SUBJECT: CATAWBA NUCLEAR STATION, UNITS 1 AND 2 – STAFF ASSESSMENT OF RESPONSE TO 10 CFR 50.54(f) INFORMATION REQUEST – FLOOD-CAUSING MECHANISM REEVALUATION (CAC NOS. MF3625 AND MF3626)

STAFF ASSESSMENT BY THE OFFICE OF NUCLEAR REACTOR REGULATION
RELATED TO FLOODING HAZARD REEVALUATION REPORT
NEAR-TERM TASK FORCE RECOMMENDATION 2.1
CATAWBA NUCLEAR STATION, UNITS 1 AND 2
DOCKET NOS. 50-413 AND 50-414

Figure 3.3-1. Historical Development of Catawba River Model (Derived from HDR Engineering, 2014)

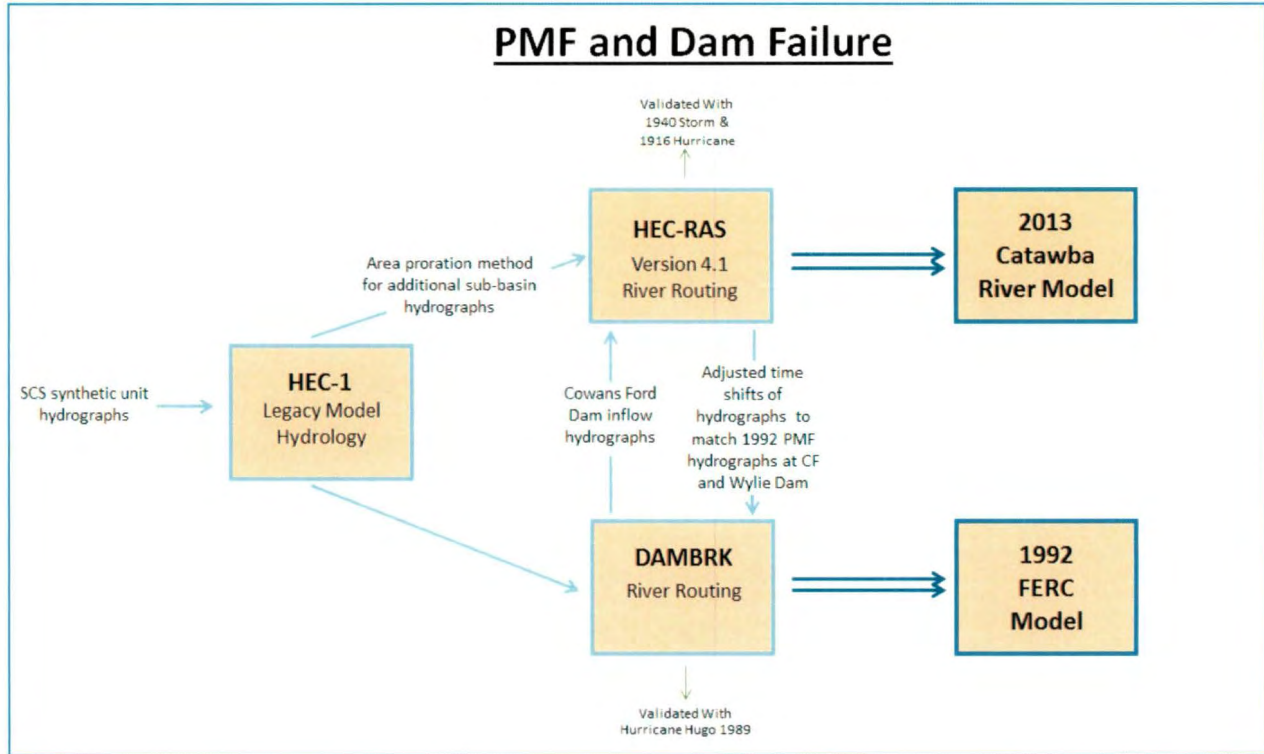
The licensee evaluated flooding in streams and rivers by simulating the passage of the PMF through each Duke dam and reservoir in the Catawba-Wateree Basin. The reevaluated model, herein known as the 2013 Catawba River Model, is based on several components from previous models used in the past. Figure 3.3-1 of this staff assessment depicts the model development history (Duke, 2104b). The FHRR (Duke, 2014b) states that the licensee's PMF reevaluation is based on the 1992 PMF evaluation performed as part of the Federal Energy Regulatory Commission (FERC) compliance activities. The PMF evaluation was performed using the HEC-1 (USACE, 1998) hydrologic model to develop rainfall-runoff hydrographs for the tributary watersheds and the DAMBRK hydraulic model (Fread, 1991) to route the PMF along the Catawba River. The model uses a regional Soil Conservation Service (SCS) unit hydrograph methodology (SCS, 1986) to simulate the runoff response for excess rainfall for the Catawba River sub-basins. The lag time is determined by varying the unit hydrograph lag time until the calculated sub-basin runoff hydrograph approximately coincides with the observed sub-basin gage hydrograph for each analyzed storm. The licensee tabulated lag times for each basin and storm event and calculated an average basin lag time (Duke, 2014b).

The licensee stated in its FHRR (Duke, 2014b) that they adopted the HEC-1 model to develop the inflow hydrographs for the 2013 Catawba River Model. They replaced the DAMBRK routing model with the Hydrologic Engineering Center - River Analysis System (HEC-RAS) Version 4.1 (USACE, 2010) model in order to determine maximum water surface elevations at Catawba, Units 1 and 2. The licensee used the DAMBRK model to establish the timing of the inflow hydrographs. To maintain consistency with the 1992 DAMBRK model, the licensee combined select inflow hydrographs and added additional tributary inflows. The licensee applied area proration to the sub-basin inflow hydrographs to distribute the flow within the modeled tributary reaches in the 2013 Catawba River Model, conserving the total inflow hydrograph for each respective sub-basin. The licensee made time adjustments to individual inflow hydrographs so that the superposition of the routed hydrograph reasonably matched the FERC approved 1992 PMF hydrographs for the Cowans Ford and Wylie subbasins.

Since most of the major dams on the Catawba River did not exist during the 1916 and 1940 storm events that were used in calibrating the river model, the licensee explained that unit hydrographs had been developed and used in the model to predict flow at the dams that existed at the time of the historical flooding events, and model predictions had been compared with available data on observed conditions during the historical events (Duke, 2015 and NRC, 2016b). The licensee also noted that the main emphasis had been on flows in the upper parts of the watershed. The staff confirmed that the described approach is consistent with current methods and is reasonable for the purposes of the 50.54(f) letter.

Figure 3.4-1. Overview map of Catawba River watershed, showing major dams, reservoirs, and sub-watersheds (derived from Duke, 2014b)

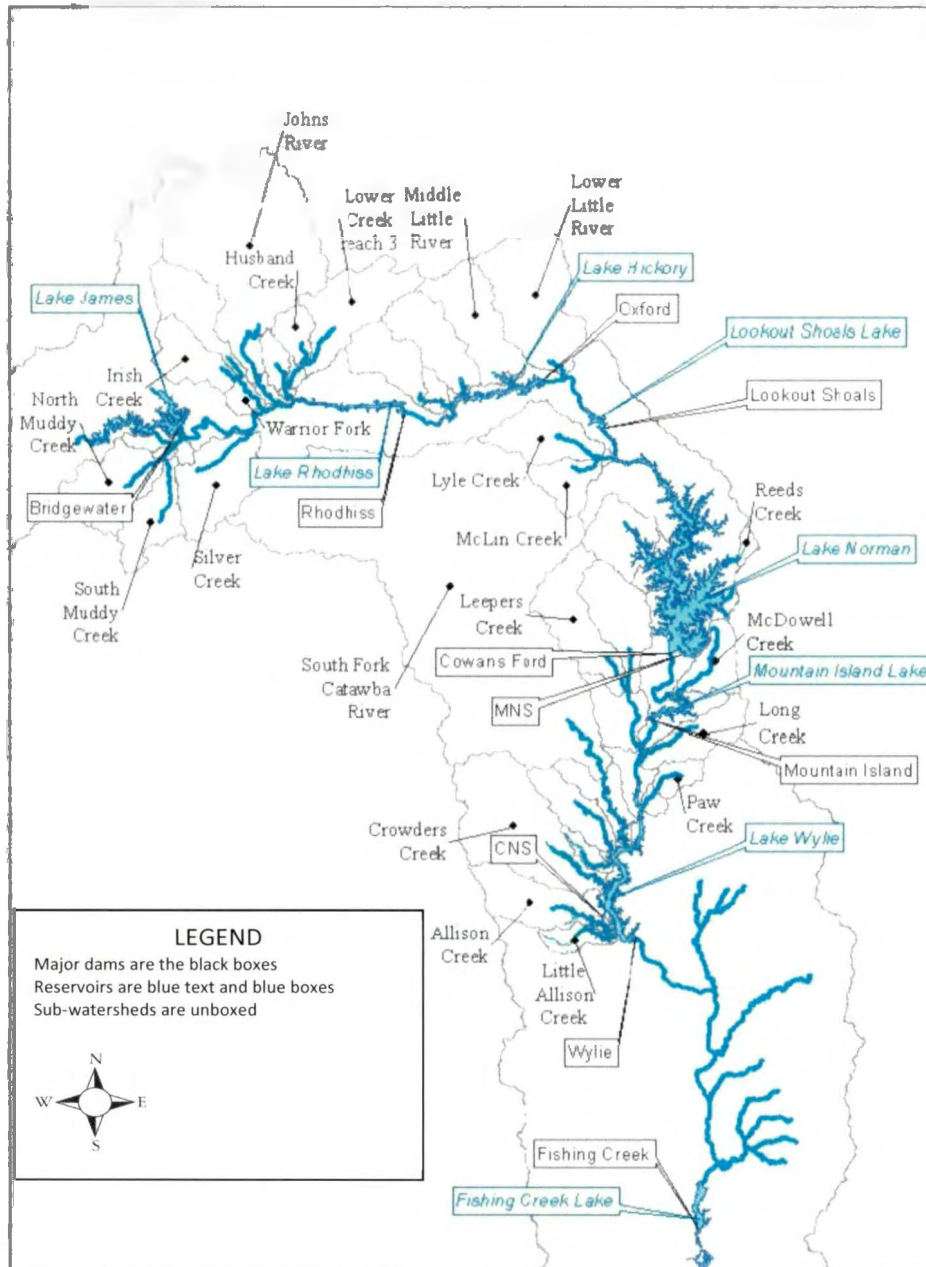
The licensee stated in the FHRR (Duke, 2014b) that there are a total of 11 hydroelectric reservoirs and 13 FERC-regulated hydroelectric dams and powerhouses along the Catawba River. Duke owns and operates the Wylie Dam and six other major reservoir developments upstream from Lake Wylie that regulate flows on the Catawba River. These upstream dams and their associated reservoirs are the Bridgewater development (including Paddy Creek, Linville, and Catawba dams) and Lake James; Rhodhiss Dam and Lake Rhodhiss; Oxford Dam and Lake Hickory; Lookout Shoals Dam and Lake; Cowans Ford Dam and Lake Norman; and Mountain Island Dam and Lake (Figure 3.4-1) (Duke, 2014b).

As a basis for the analysis of the flooding hazard from dam failure, the licensee conducted a screening process to identify the appropriate Catawba River basin dams to include in its analyses of dam failure effects at the Catawba site (Duke, 2014b). The licensee identified all Duke hydroelectric dams as critical dams due to their large storage capacity and locations. The licensee removed very small dams from consideration due to the low cumulative water-level increase (approximately 0.1 ft (0.03 m) in Lake Wylie). The licensee identified 12 major dams out of 262 upstream of the Catawba site applicable to the dam failure analysis. The staff confirmed that the licensee's dam screening approach is consistent with the Interim Staff Guidance JLD-ISG-2013-01 (NRC, 2013b) and therefore, agrees with the selection of dams that were analyzed.
